May 2, 2024
AVO 37449.004

Re: Lane Ranch Phase 1 Preliminary Plat -Review #3

Halff Associates, Inc. was requested by the City of Sanger to review the Preliminary Plat for Lane Ranch Phase 1. The submittal was prepared by Middleton and Associates, LLC and was dated February 2, 2024.

PAVING PLAN & PROFILE
BUTTERFIELD DRIVE
STA. 0+00 - 7+00
LANE RANCH, PHASE 1

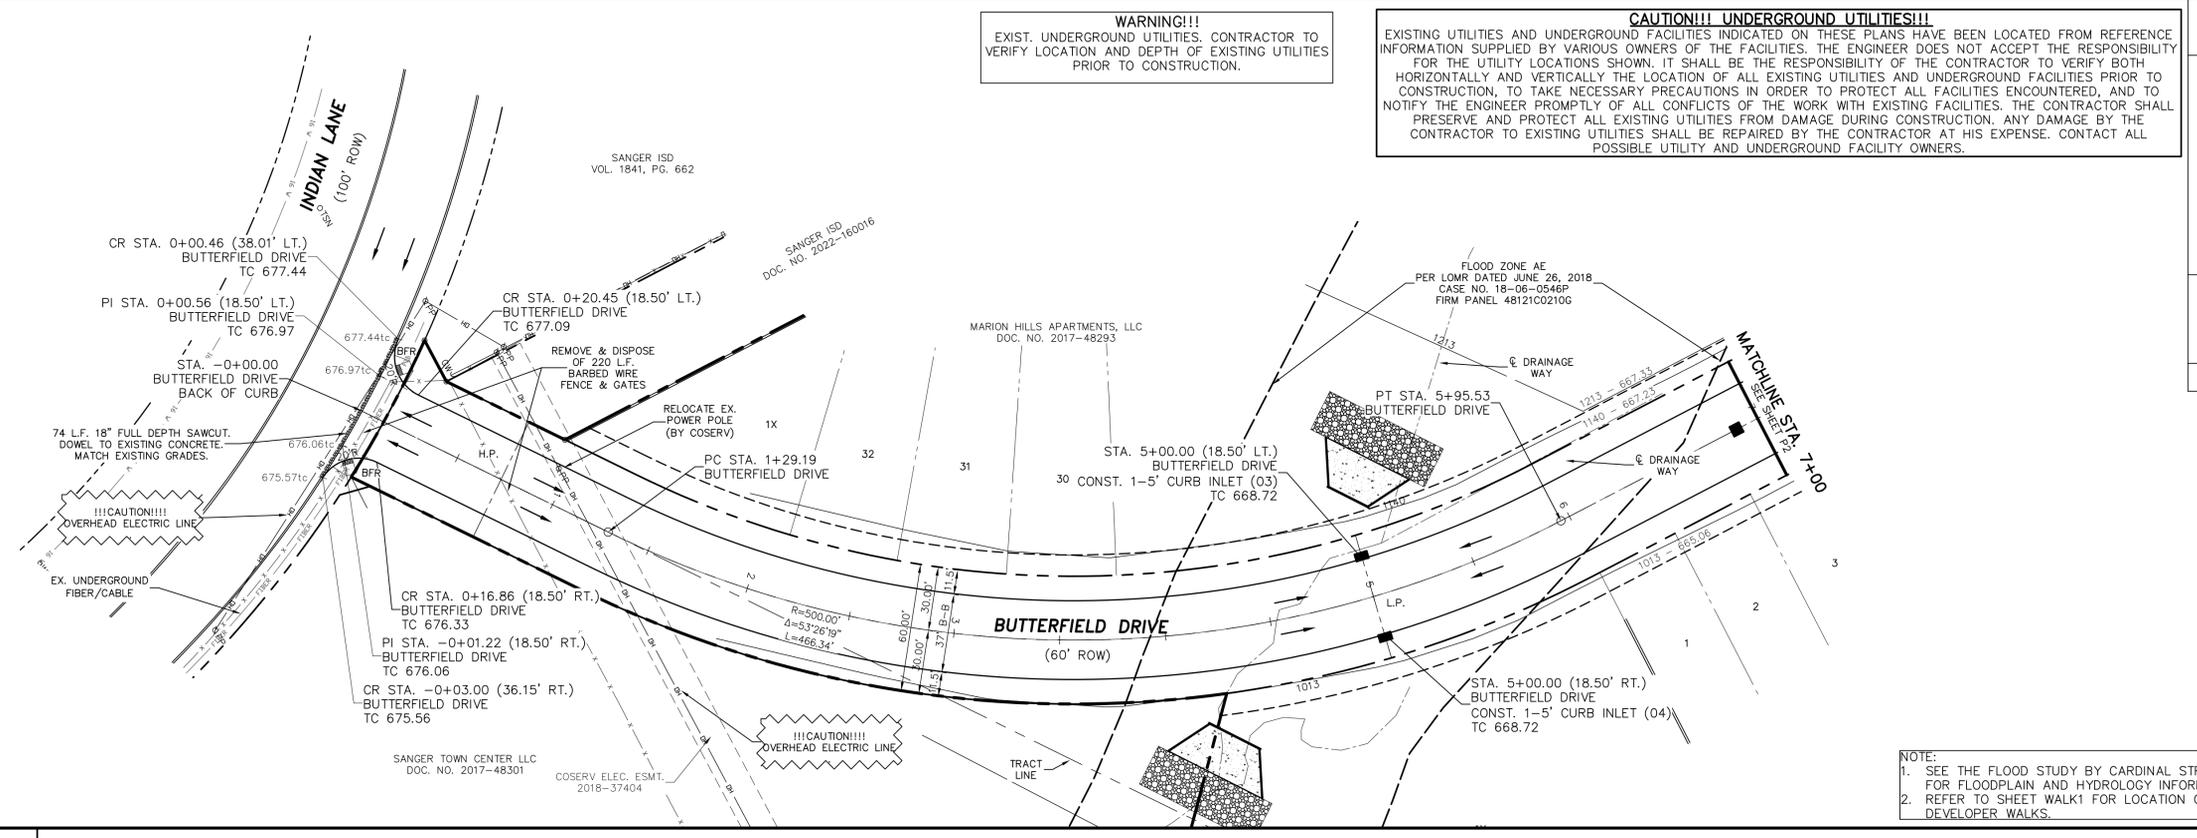
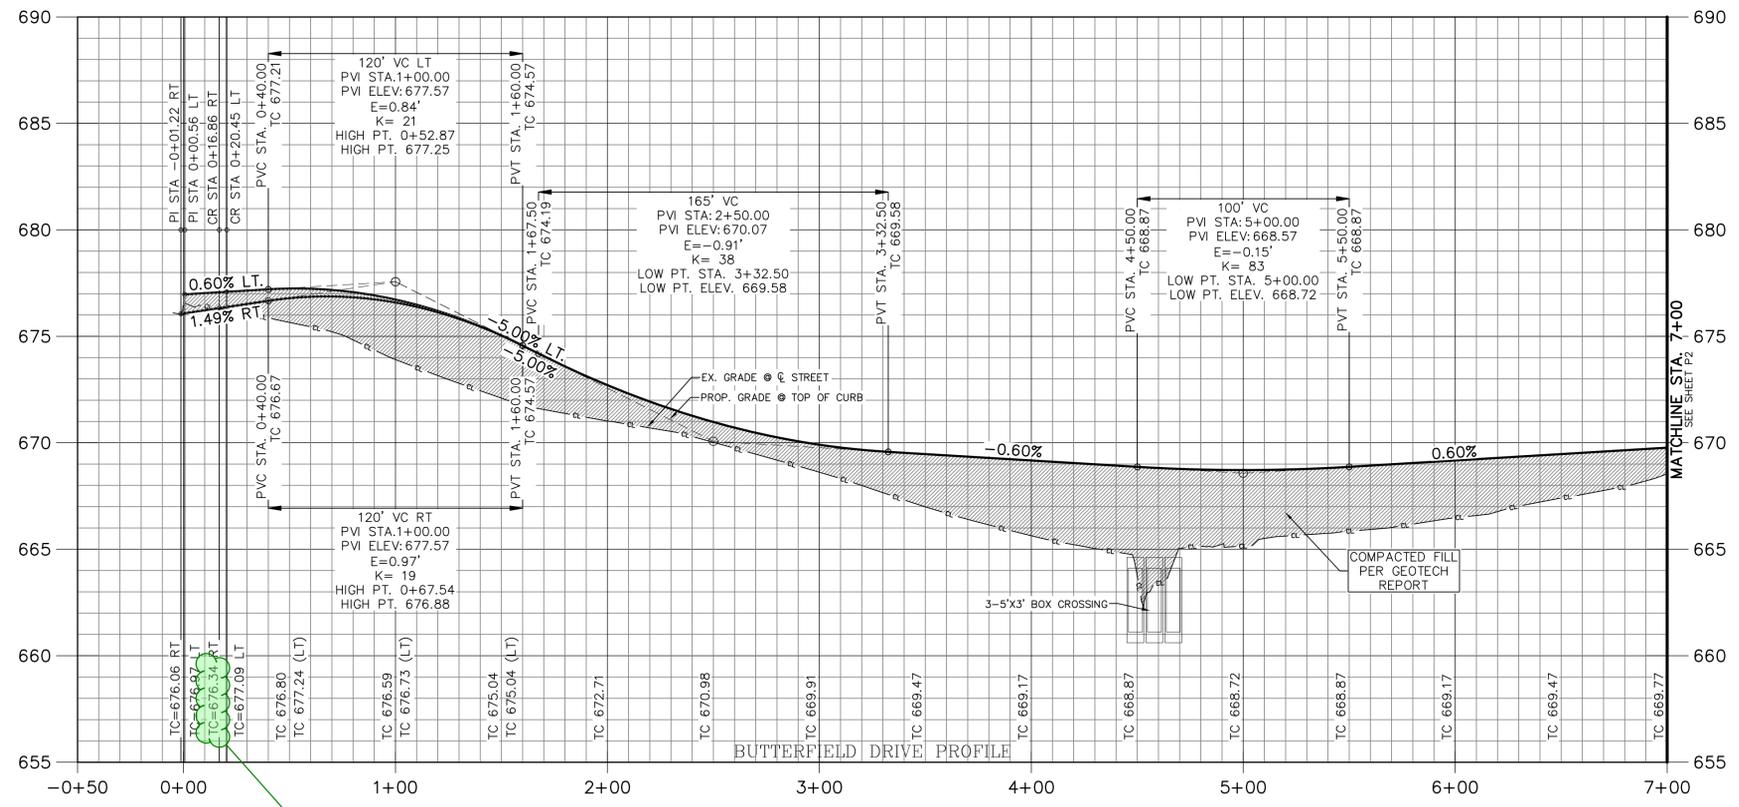
Does not Match Plan view

PAVING PLAN & PROFILE
BEE BALM LANE
STA. 14+20 - END
LANE RANCH, PHASE 1

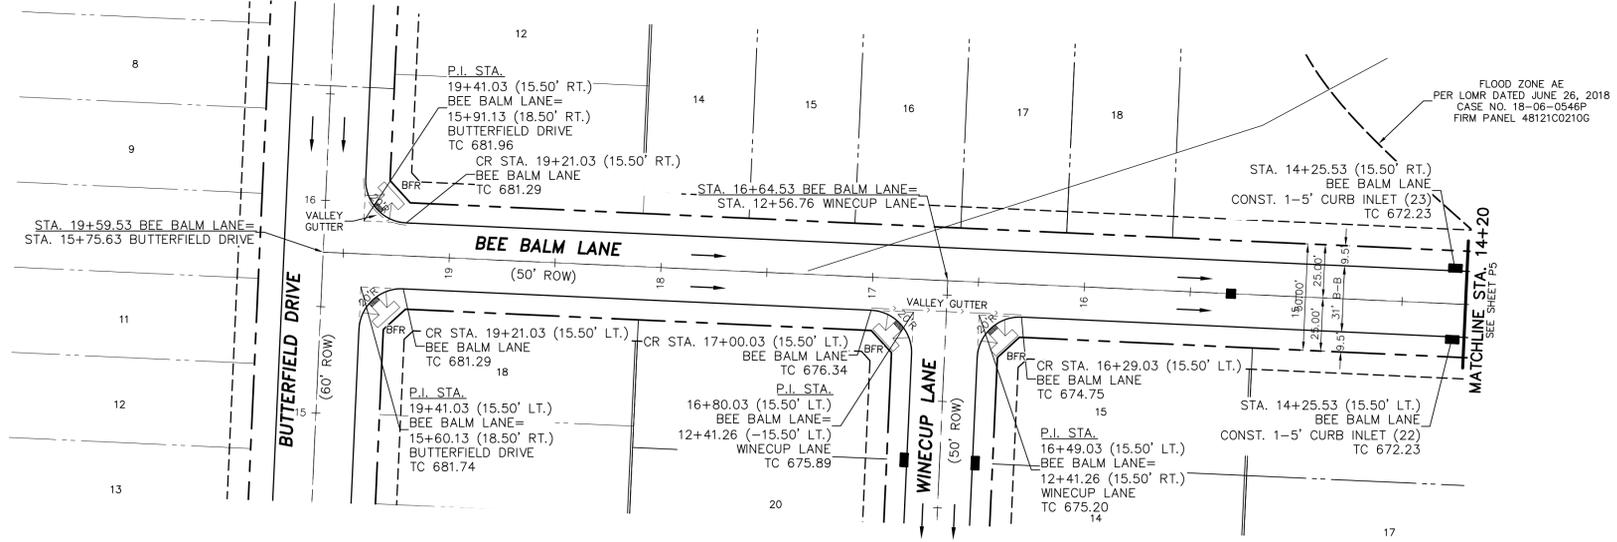
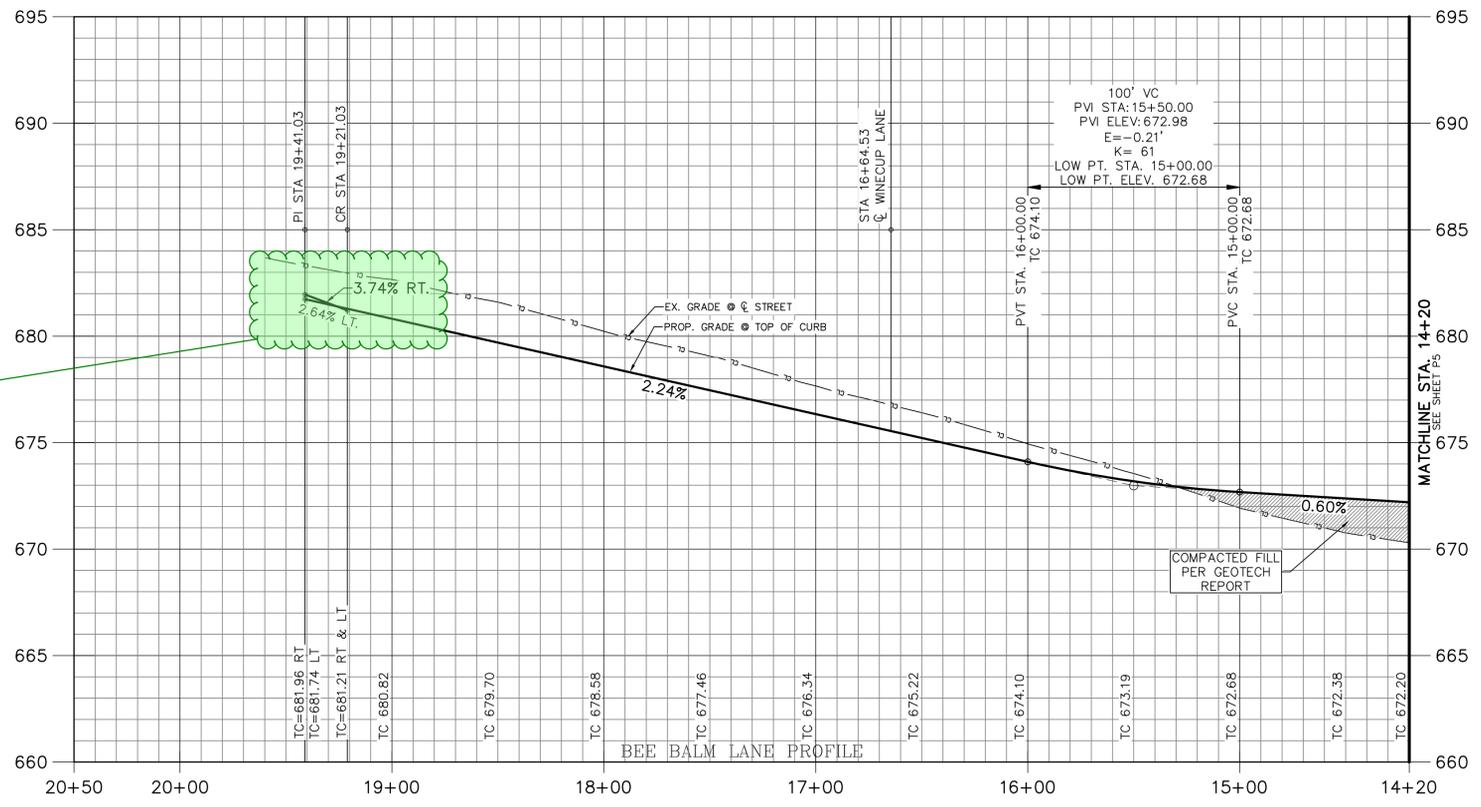
Maximum longitudinal slopes within one hundred feet (100') of intersections shall not exceed two percent (2%) 10.106(b)(4).

PAVING PLAN & PROFILE
WINECUP LANE
STA. 6+00 - END
LANE RANCH, PHASE 1

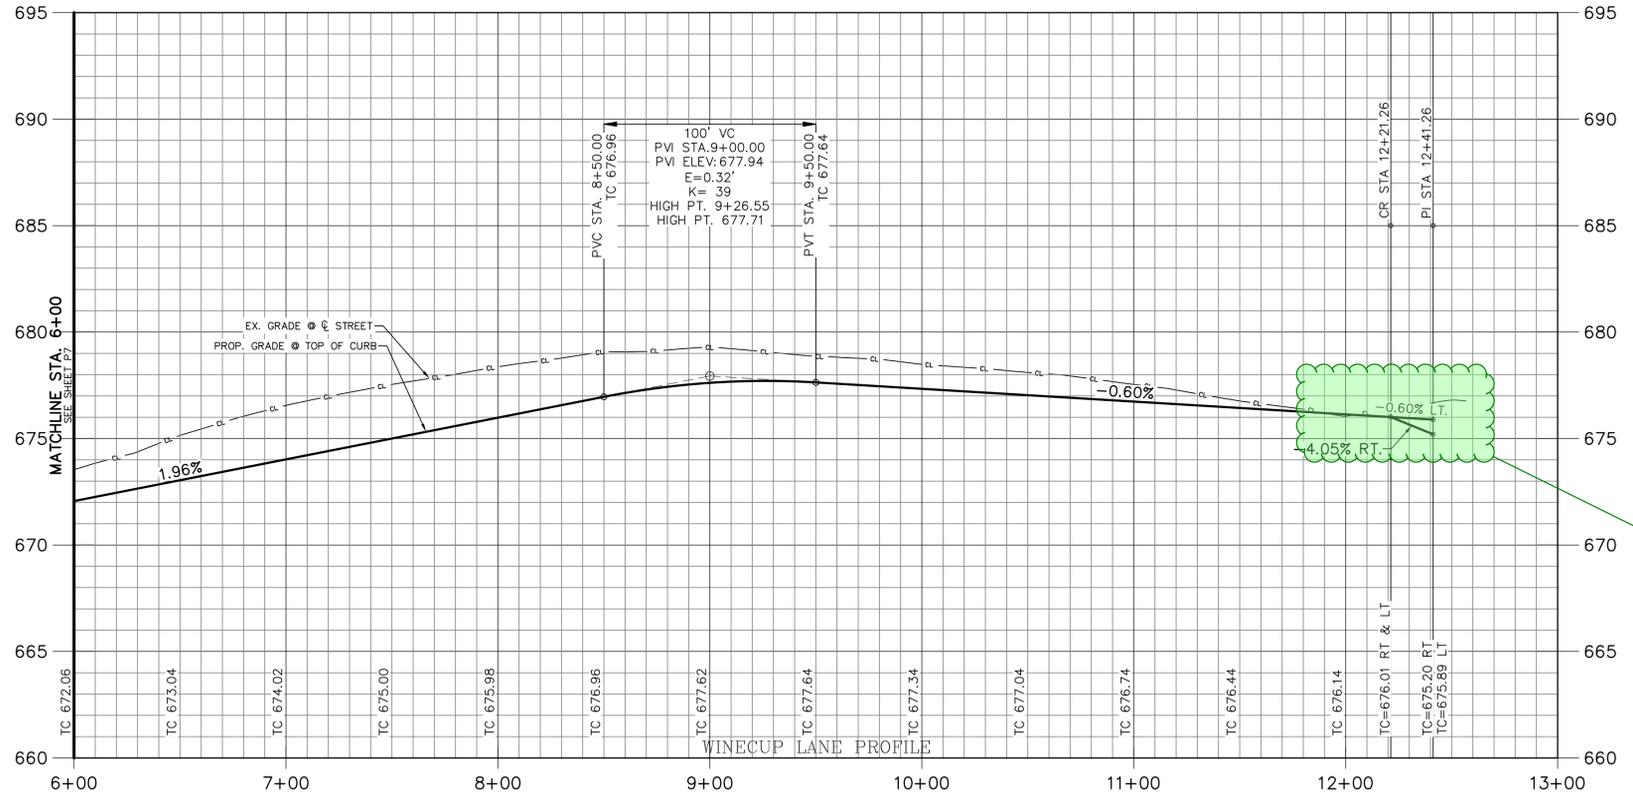
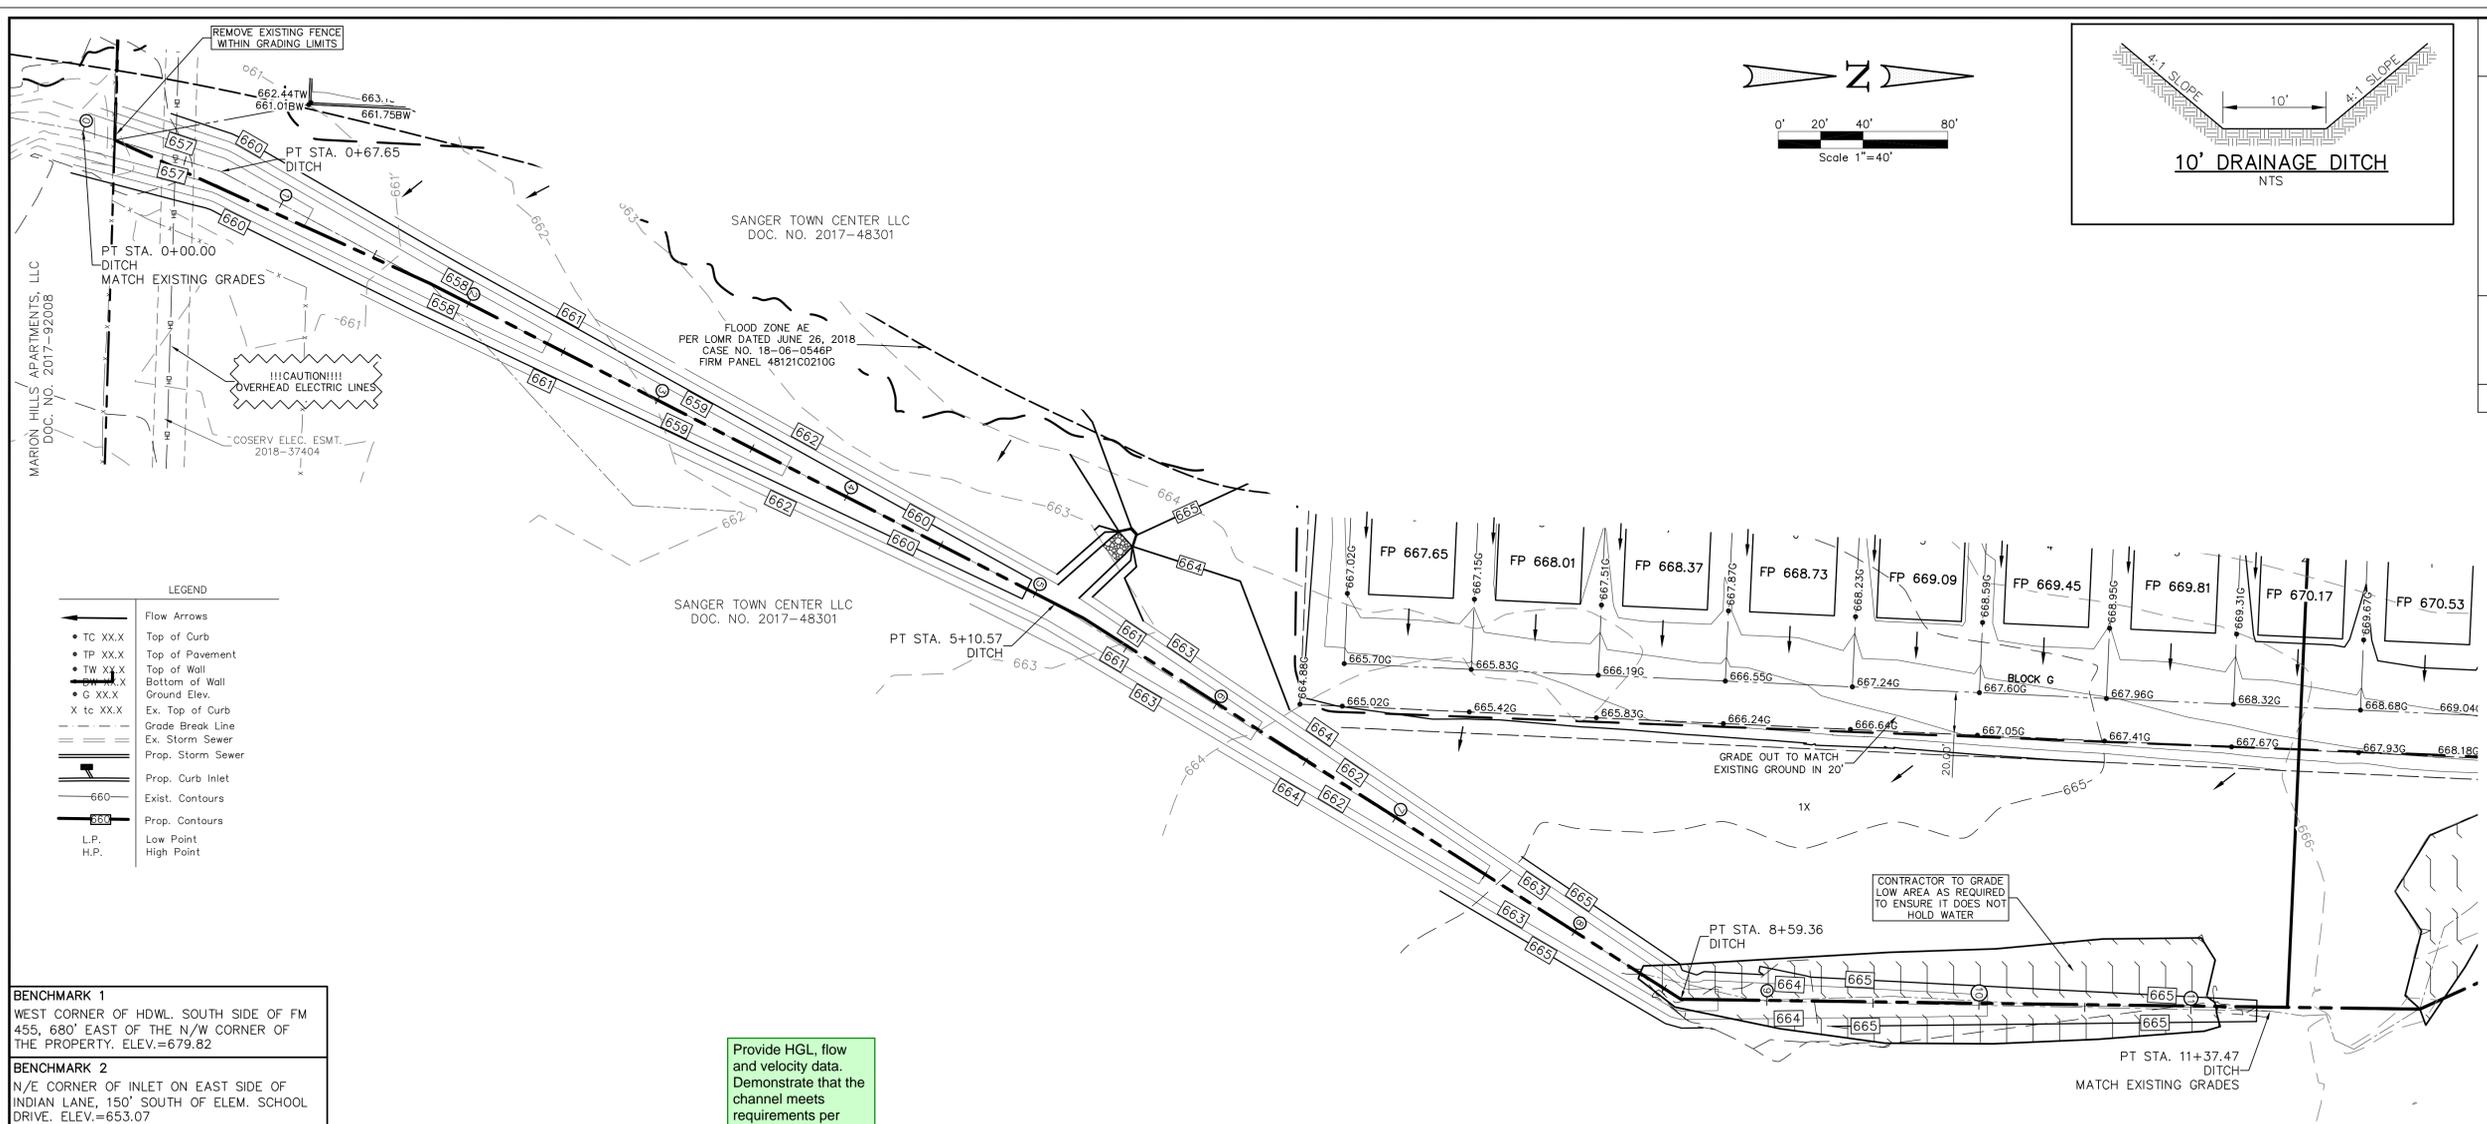
Maximum longitudinal slopes within one hundred feet (100') of intersections shall not exceed two percent (2%) 10.106(b)(4).

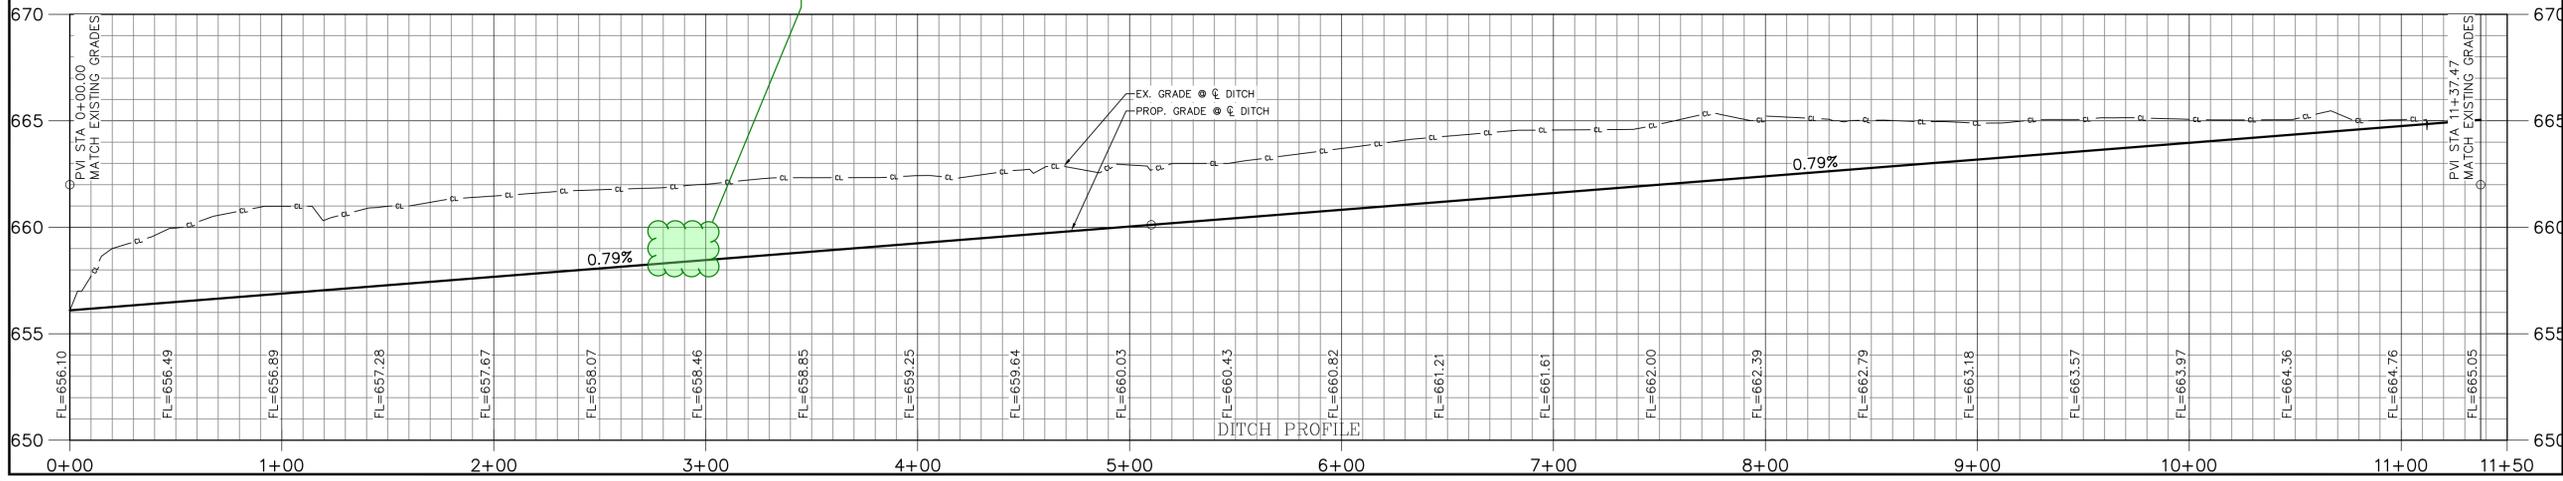
Provide HGL, flow and velocity data. Demonstrate that the channel meets requirements per ordinance 10.106(d)(9)(B)
